BGA TECHNICAL COMMITTEE

Technical Newsheet. TNS2/3/78.

"DUSTER" Change Bulletin  
MANDATORY

MANDATORY FIN & RUDDER MODIFICATION - Jan 12-78 H.E. PIER

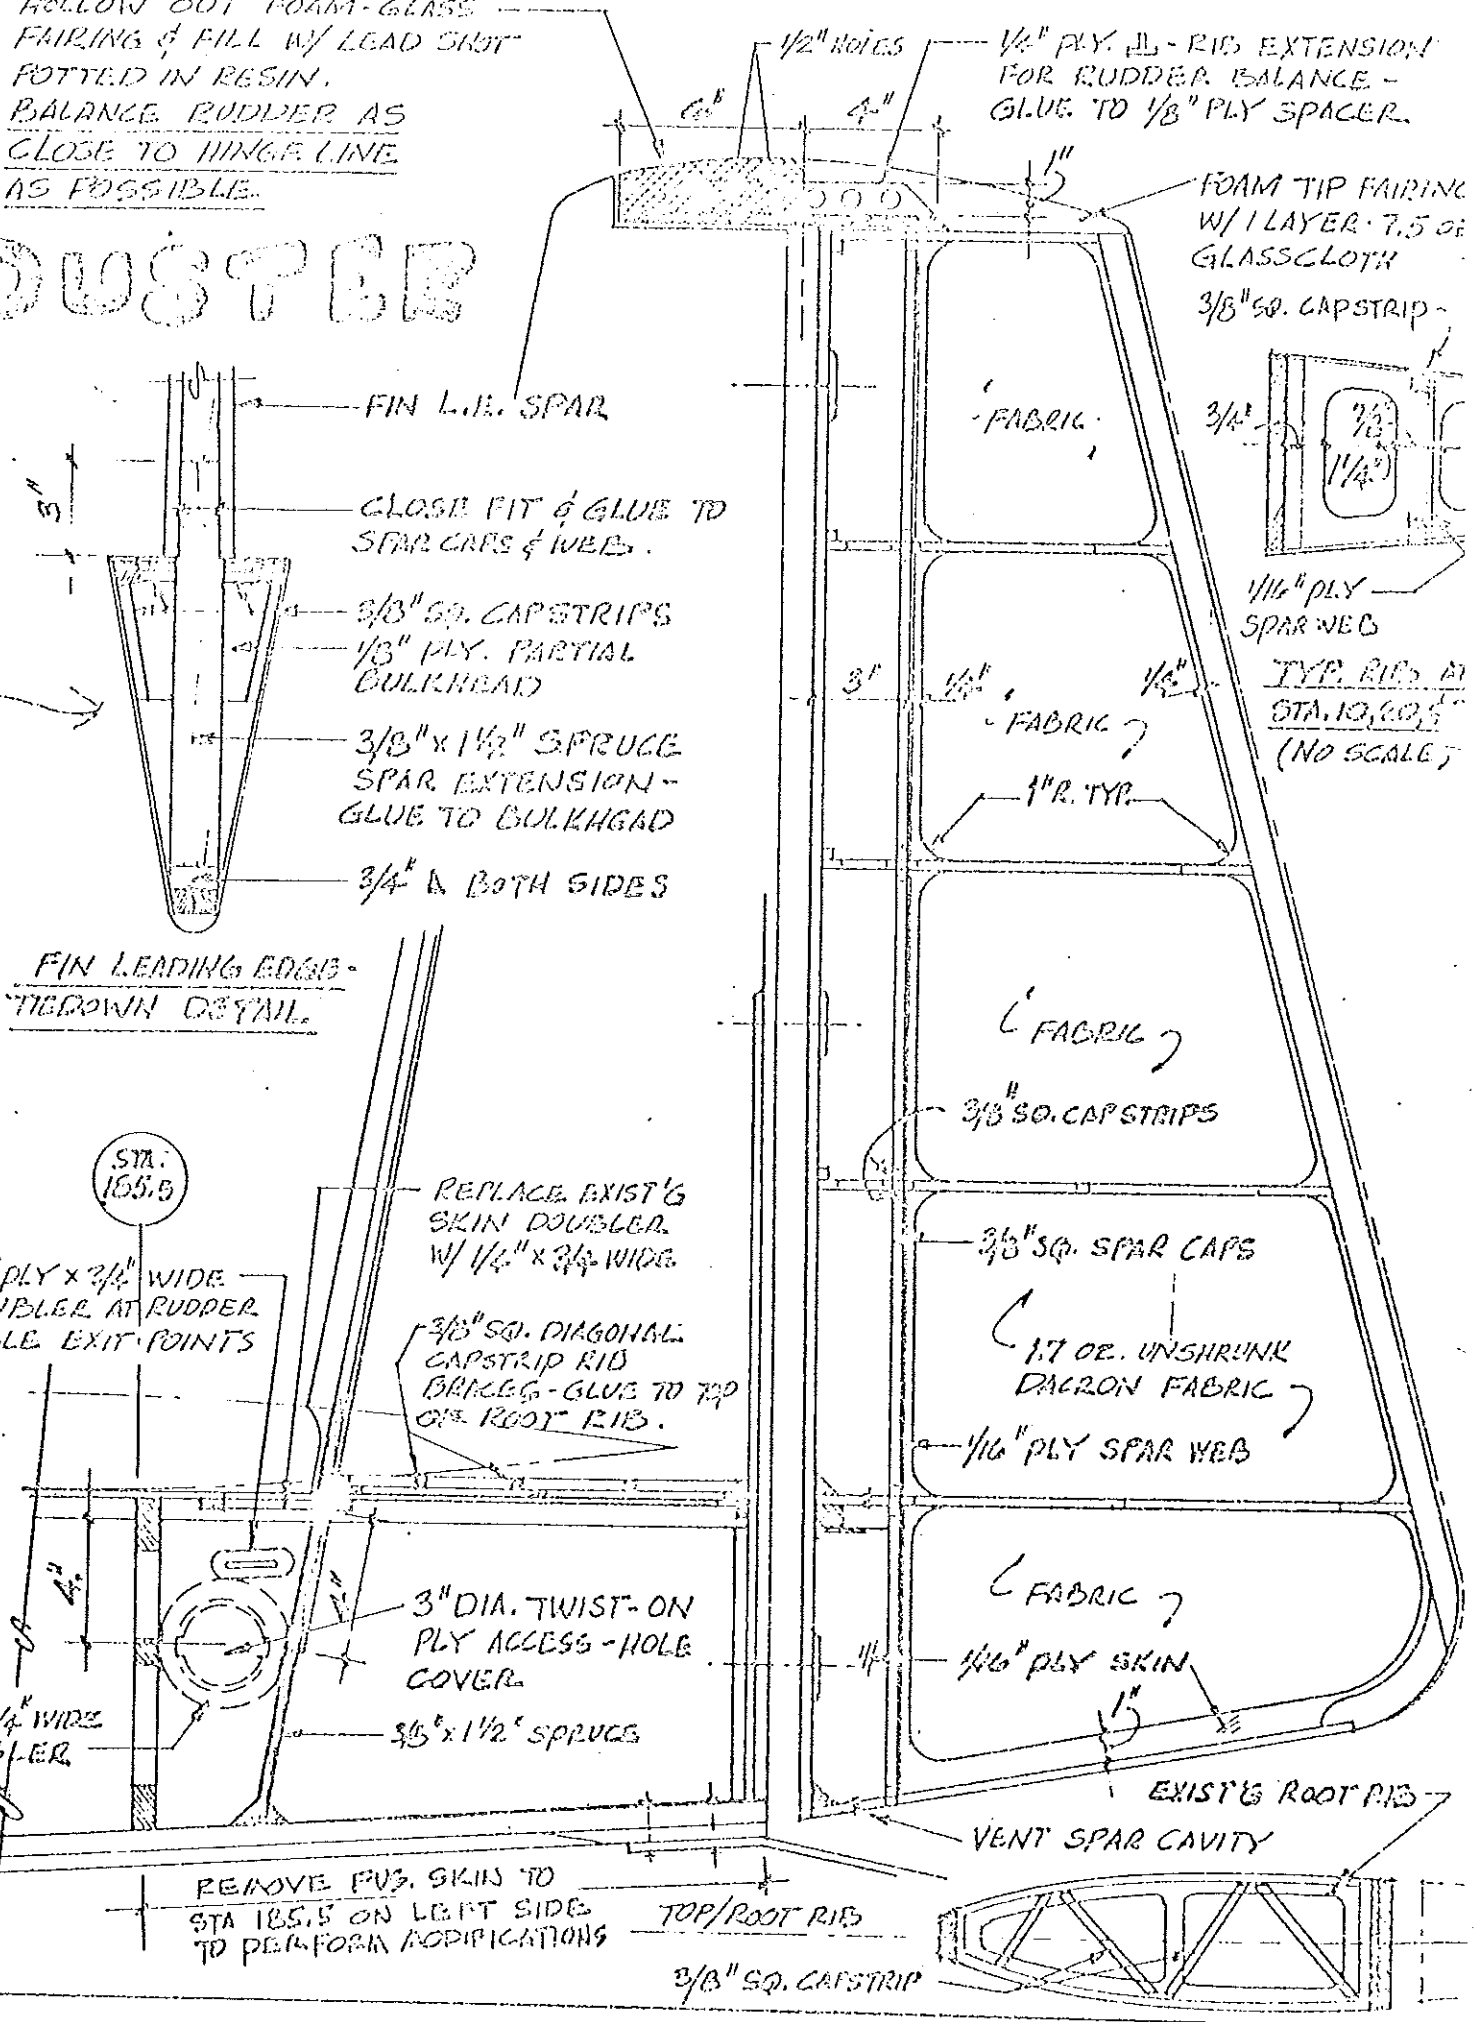
- A. Install a partial bulkhead which ties the fin leading-edge into the fuselage structure. (see enclosed dwg)
- B. Replace skin doubler at elevator control-horn slot in fuselage deck with 1/4"x3/4" wide doubler, extending it behind the fin leading-edge extension.
- C. Install access-hole cover (smaller and relocated downward) on left side of fuselage aft of sta. 185.5 .
- D. Install 1/8"x3/4" wide skin doubler inside fuselage skins at rudder cable exit points.
- E. Install 3/8" capstrip bracing on top side of fin root-rib.
- F. Replace rudder with redesigned fabric-covered and balanced unit.
- G. Lower  $V_{ne}$  to 100 knots.

The above modifications will necessitate removal of the left-side fuselage skin aft of sta. 185.5 . A standard (ten x t) scarf joint is called for, centered over the bulkhead at sta. 185.5, so take care when removing the discarded skin piece that the area to be scarfed remains intact on the fuselage.

*DUSTER PLANS HAVE BEEN CHANGED TO SHOW FIN LEADING EDGE WEB AND CAP STRIPS RUNNING FULL DEPTH INTO FUSELAGE TO FORM A LEADING EDGE SPAR-WEB/BULKHEAD.*

HOLLOW OUT FOAM-GLASS FAIRING & FILL W/ LEAD SHOT POTTED IN RESIN. BALANCE RUDDER AS CLOSE TO HINGE LINE AS POSSIBLE.

FIN LEADING EDGES - TIEDOWN DETAIL.

3" PLY X 3/4" WIDE DOUBLER AT RUDDER VISIBLE EXIT POINTS

REPLACE EXIST'G SKIN DOUBLER W/ 1/2" X 3/4" WIDE

3/8" SQ. DIAGONAL CAPSTRIP RIB BRACES - GLUE TO TOP OF ROOT RIB.

3" DIA. TWIST-ON PLY ACCESS-HOLE COVER

REMOVE FV3 SKIN TO STA 185.5 ON LEFT SIDE TO PERFORM MODIFICATIONS

1/2" PLY. PL - RIB EXTENSION FOR RUDDER BALANCE - GLUE TO 1/8" PLY SPACER.
